Cambridge City Council

Responses to the Examining Authority's second written questions and requests for information (ExQ2)

Application by Anglian Water Limited for an Order Granting Development Consent for the Cambridge Waste Water Treatment Plant Relocation project (CWWTPR) (ref: WW010003)

Response to ExA's Second Written Questions (ExQ2)

Appendix 1: Map 0

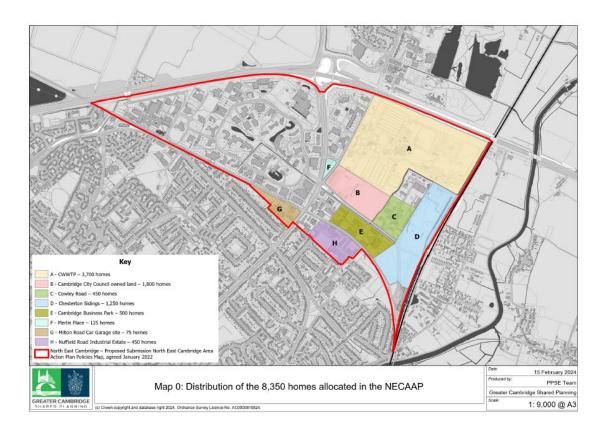
SCDC and CCC also propose that further text be included at paragraph 6.34 of both LIRs where the issue of dwelling numbers is first addressed, to explain the distribution and breakdown of the 8,350 homes allocated in the NECAAP, and in particular to clarify how many homes are assumed on the CWWTP site itself and the adjoining City Council owned land. It also clarifies the number of homes that are enabled by the relocation of the CWWTP. A new Map 0 is proposed to illustrate the distribution of homes. The changes proposed are as follows:

A new Map, "Map 0", appended to this document is proposed to be included below, which shows the distribution of all the allocated homes more explicitly.

"6.34 The vast majority of the proposed allocation of 8,350 dwellings in the NECAAP are constrained by the presence of the CWWTP. There are a total of 6,925 homes within the odour contours that would be enabled by the relocation of the CWWTP. The areas identified for residential development are shown on the land use plan in the NECAAP as Figure 11 [Appendix 1 GCSP-7]. The NEC Typologies Study and Development Capacity Assessment (December 2021) [Appendix 1, GCSP- 19] includes Appendix A: Site Assessment Table that sets out the land parcels proposed for new homes. The distribution of housing is also shown on Map 0 below for completeness. The CWWTP site itself would accommodate 3,700 homes, whilst the adjoining land owned by the City Council would accommodate 1,800 homes, such that land being brought forward jointly by the Applicant and the City Council would deliver a total of 5,500 homes. The latest information on the area constrained by the odour contours as it affects the CWWTP is the Odour impact assessment for Cambridge Water Recycling Centre October 2018 [Appendix 1, GCSP-20] together with the December 2020 Addendum Report – Updated odour dispersion modelling for Cambridge Water Recycling Centre [Appendix 1, GCSP-20a], which is evidence prepared to support the NECAAP and refines the 400m consultation area in the Minerals and Waste Local Plan 2021, Policy 16 [Appendix 1 no.41).

Odour contours C98, 1-hour = 3, 5 and 6 ouE/m3 are identified as areas where residential development would be at risk of odour impact. The odour contours as they were in 2016 are shown in Fig 10 of the 2018 report [Appendix 1, GCSP-20]. The contours in Figure 1 of the Addendum Report – Updated odour dispersion modelling for Cambridge Water Recycling Centre [Appendix 1, GCSP-20a] are for 2013 and were a worst-case scenario and cover a slightly smaller area in the updated modelling. Under either scenario, the majority of the NEC area where residential development is envisaged in the NECAAP lies within the odour contours. A further 1,425 homes are allocated on land lying within the odour contours that would be enabled by the relocation of the CWWTP (Cowley Road Industrial Estate - 450; Chesterton Sidings (part) – 350; Cambridge Business Park - 500; and Merlin Place – 125 homes (noting that planning permission was granted for Merlin Place, subject to a S106 agreement, at the Joint Development Control Committee on the 24th January 2024 for employment development rather than residential))."
